SPEEDWAY BUSINESS PARK

Project No.:	AVO 25021
Issued:	07/10/2007
Drawn By:	RM
Checked By:	TJR
Sheet Title	MASTER DEVELOPMENT PLAN
Sheet Number	1 OF 1

Re: Speedway Business Park **MDP/MI-1 # 019-07**

The City Staff Development Review Committee has reviewed Speedway Business Park Master Development Plan / Mixed Light Industrial **MDP/MI-1# 019-07.** Please find enclosed a signed copy for your files. Your plan was accepted, however, please note the following conditions:

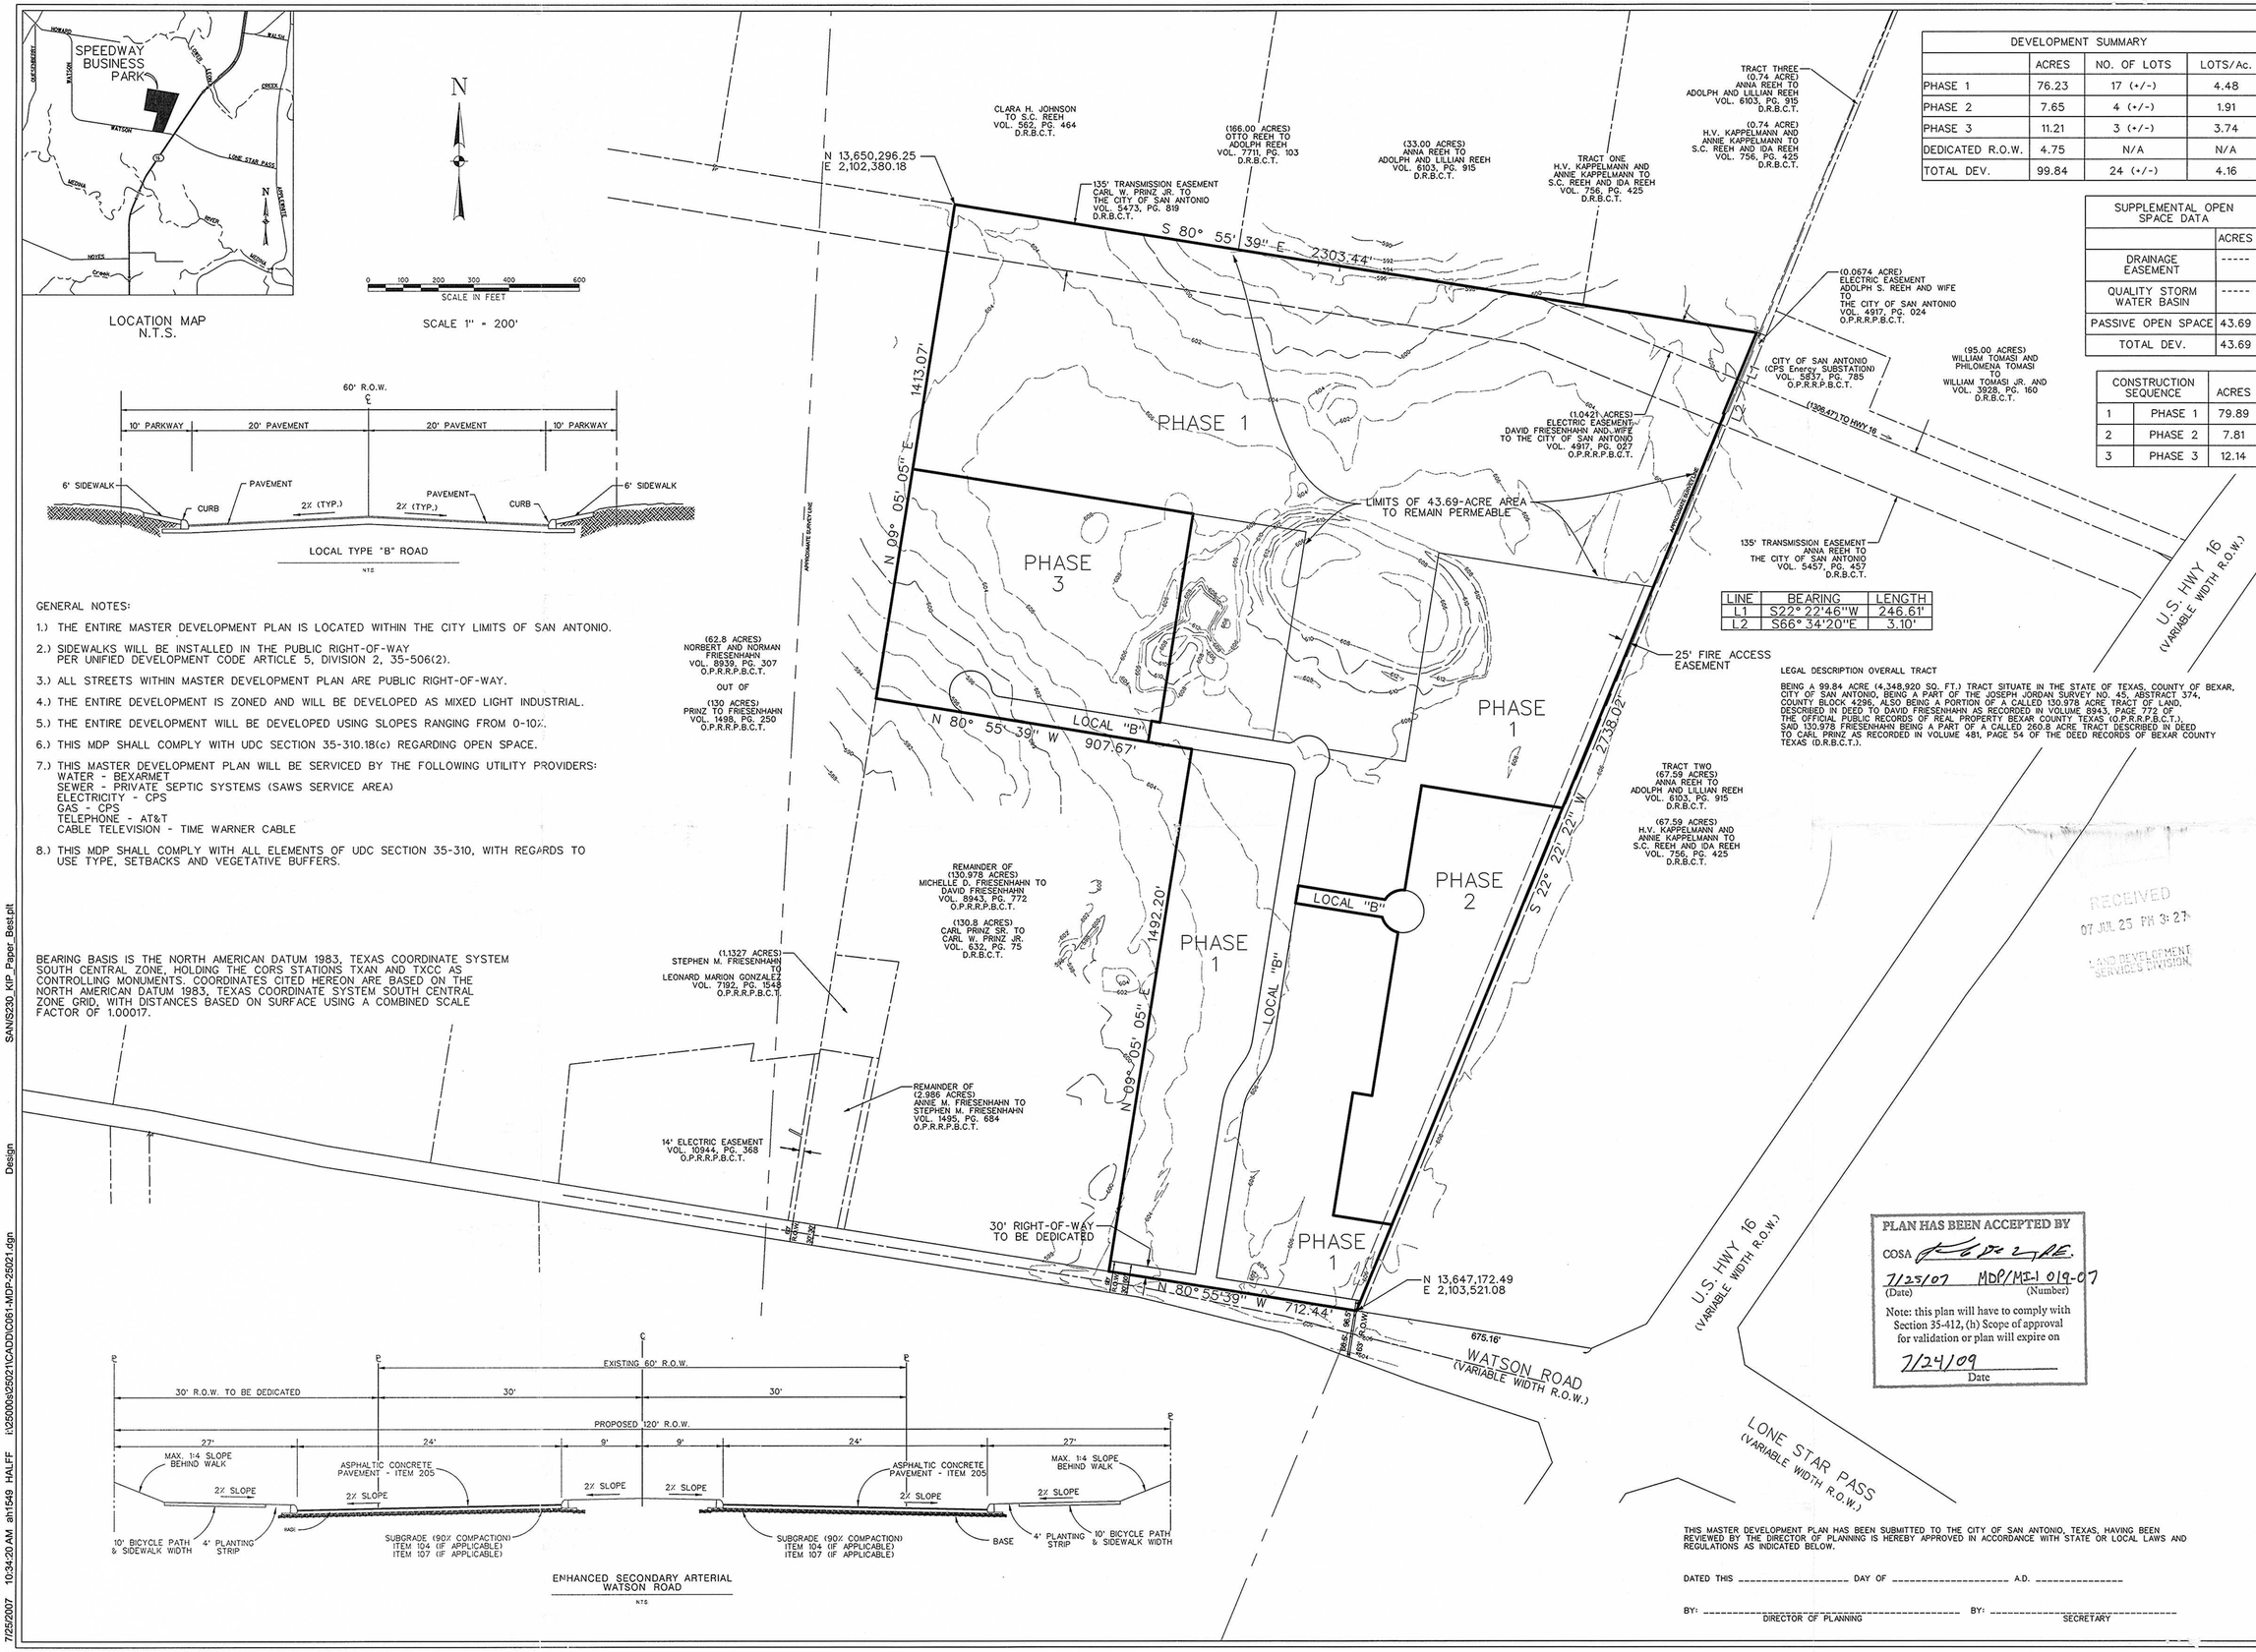
In consideration of public safety and convenience, excessive grades by reason of topography should be avoided in street layouts and arrangements. Any access and right-of-way issues along state facilities will need to be resolved with the **Texas Department of Transportation (TXDOT)**. For information about these requirements you can contact TXDOT at 615-5814.

- All commercial driveways shall comply with UDC 35-506(r).
- All roadways shall conform to 35-310.18(b).
- All sidewalks shall comply with UDC 35-506(q).
- All access roadways shall provide clear sight distance on all existing and proposed roadways in order to provide adequate obstruction free viewing distances for approaching traffic. All signage, landscaping, and improvements shall be selected and located so as to not block these clear sight distance areas.
- The developer shall be responsible for providing right-turn deceleration lanes with storage lengths and bat taper in proposed driveway "A" as it relates to the submitted TIA traffic counts, UDC 35-502 (a)(7), subsection C.

- UDC section 35-310.18(c) *"MI-1" Parks and Open Space* requires that 15 percent of the site be retained in permanent open space with either undisturbed natural plant materials or maintained landscaped areas. Note number 6 of the MDP reflects compliance with this section.

- 2006 Tree Preservation ordinance standards per UDC Section 35-523 – a Tree Preservation Plan is required prior to any work on site. This can be submitted either as a site work permit or at the platting stage.
- Landscape ordinance per UDC section 35-511. It appears all landscape points can be met by preserving existing vegetation as well as meeting any mitigation requirements (either through preservation of smaller material or transplanting). Recommend securing knowledgeable Landscape Architect at planning and d3esing phase to better utilize existing trees and vegetation. Preservation will eliminate the need for irrigation. Staff would be willing to meet with developer at design stage to assist with tree preservation and landscape plan.
- Additional permitting fees and affidavits will be needed to obtain tree permits during the platting and/or building permit stages.
